E/ECE/324
E/ECE/TRANS/505 } Rev.2/Add.109/Rev.1

Addendum 109: Regulation No. 110

REVIEWERS OF THIS DRAFT, PLEASE NOTE:

- Notations in Blue = discussed and ok
- Notations in Red = proposal
- Notations in Red/yellow = discussed and open.

Fig. 1-2

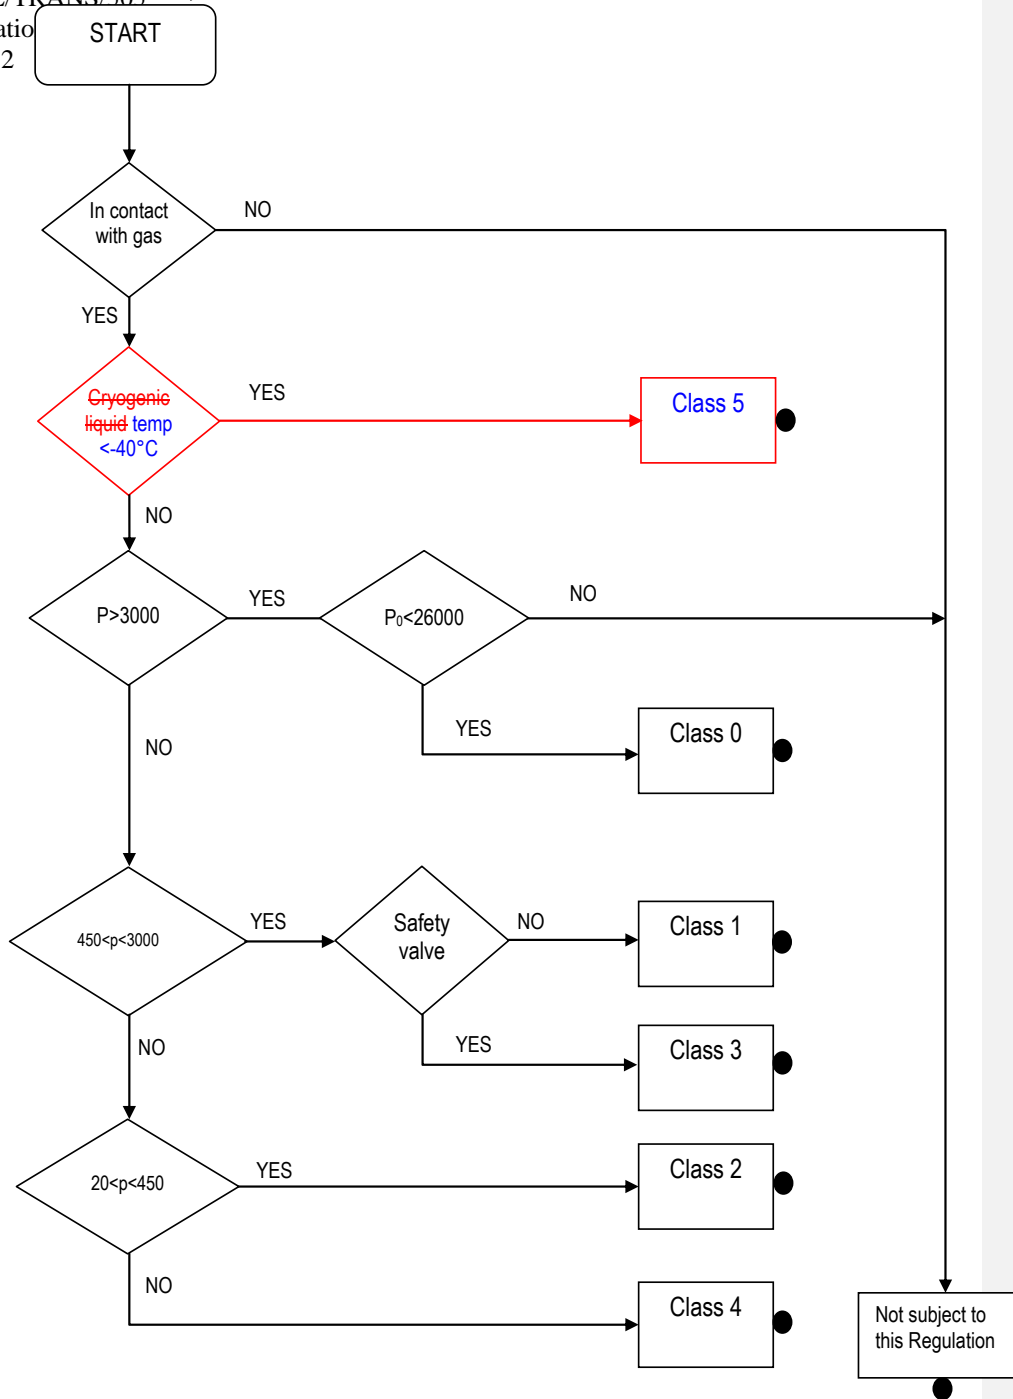
Comment [pc1]: 2 descriptions (Annex 3) mentioning the same definition.

Comment [pc2]: Non return valve replaced by check valve. Same function other name.

PROVISIONS REGARDING LNG IDENTIFICATION MARK FOR PUBLIC SERVICE VEHICLES (M2 and M3)

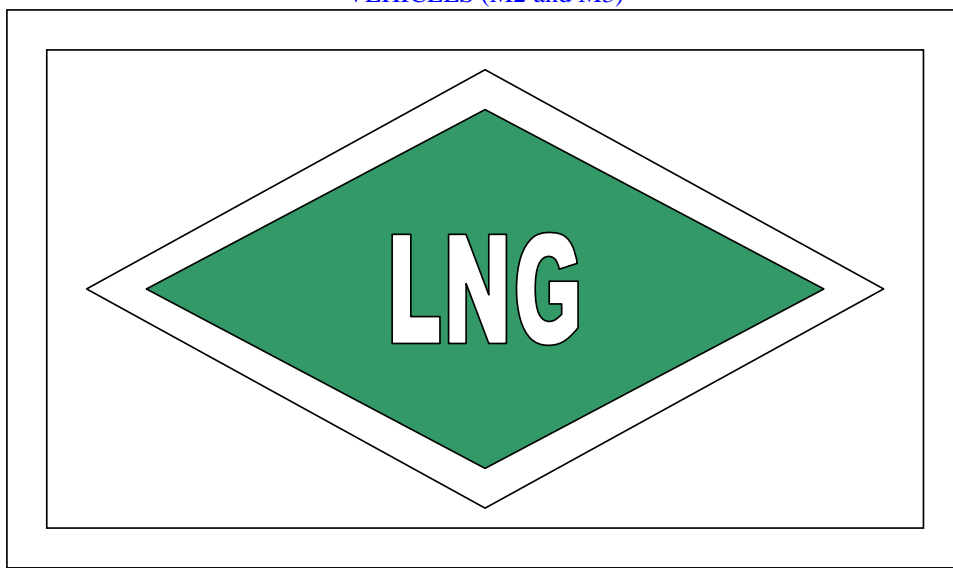
Comment [pc38]: The purpose of this label is to prevent the system for overfilling and not complying with the 5 day hold time.
